Proposed Residential Development,  
Glyntown, Glanmire

COMBINED STAGE 1 & 2 ROAD SAFETY AUDIT

<b>Client</b>	Cetti Ltd.
<b>Project Title</b>	Proposed Residential Development
<b>Document Title</b>	Combined Stage 1 and 2 Road Safety Audit
<b>Document No.</b>	MHL_22086RS-GLYTOWN GLANMIRE-DOC 01-RSA
<b>Job No.</b>	22086RS

**Photo A1** Site boundary along the nearside road edge, looking north.

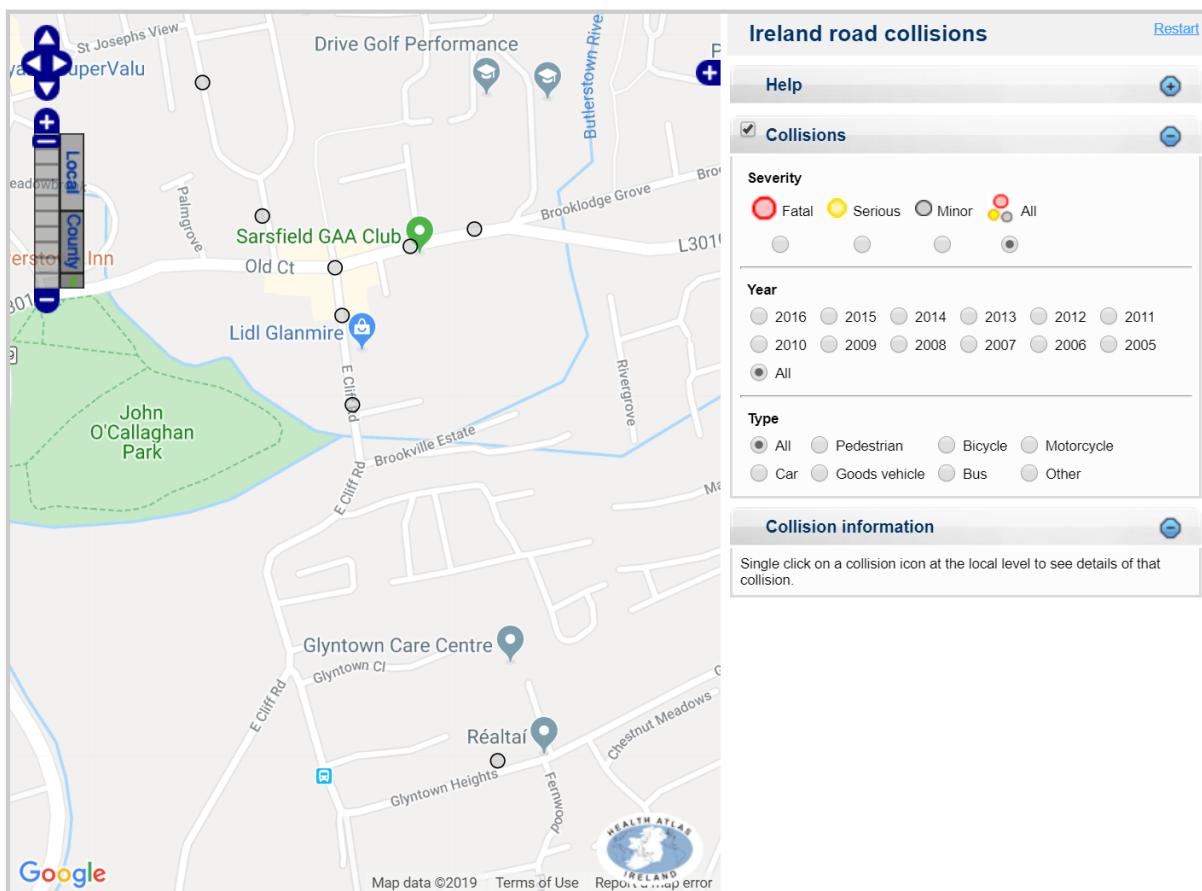
A micro pillar and a number of utility poles were observed at the existing road edge, where it is intended to construct a new roadside footpath. No reference to this pillar or poles is made in the drawings provided to the audit team. The pillar and poles, if not relocated, would represent a hazard to vulnerable road users, particularly visually impaired users and may lead to falls.

Relocate all poles and pillars off the proposed footpath to ensure that the footpath space is not restricted.
